MEMORANDUM

TO: Newberg Planning Commission
FROM: Keith Leonard, Associate Planner
SUBJECT: Supplemental packet for September 13, 2018 Planning Commission meeting
DATE: September 10, 2018

To: Newberg Planning Commission
From: Jeffrey L. Kleinman
Date: September 6, 2018
Re: Crestview Crossing, File No. PUD18-0001/CUP18-0004

Re: Crestview Crossing Development – Newberg, Oregon
Transportation Facilities Review – Crestview Drive and Six-Party Agreement

Oxberg Water System Drinking Water Source Susceptibility

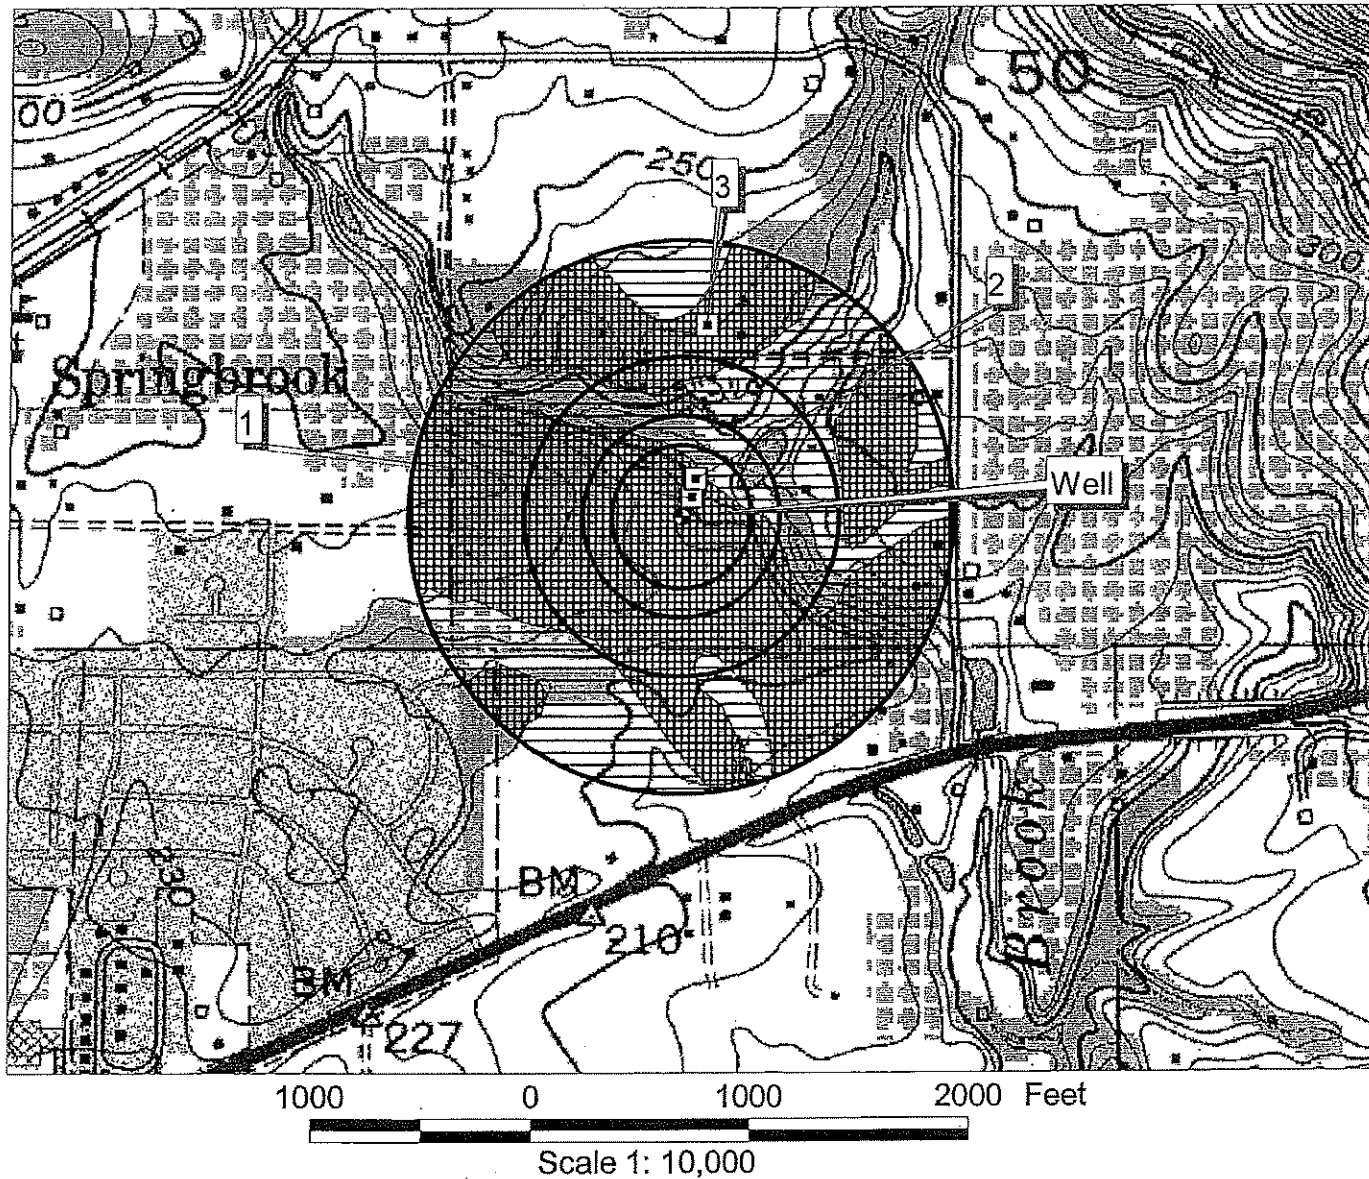
The conclusion that the Oxberg well is completed in a confined aquifer is not warranted by the available observations. Water level data instead indicate that there may be effective hydraulic communication with the surface as indicated by local equilibration between surface water and groundwater levels. A semi-confined aquifer with irregularly distributed productive intervals is more consistent with the geologic and water level observations. While the infiltration tests conducted by GeoEngineers are encouraging regarding potential impacts from infiltration, the representativeness of those results across the Crestview Crossing project site remains uncertain.
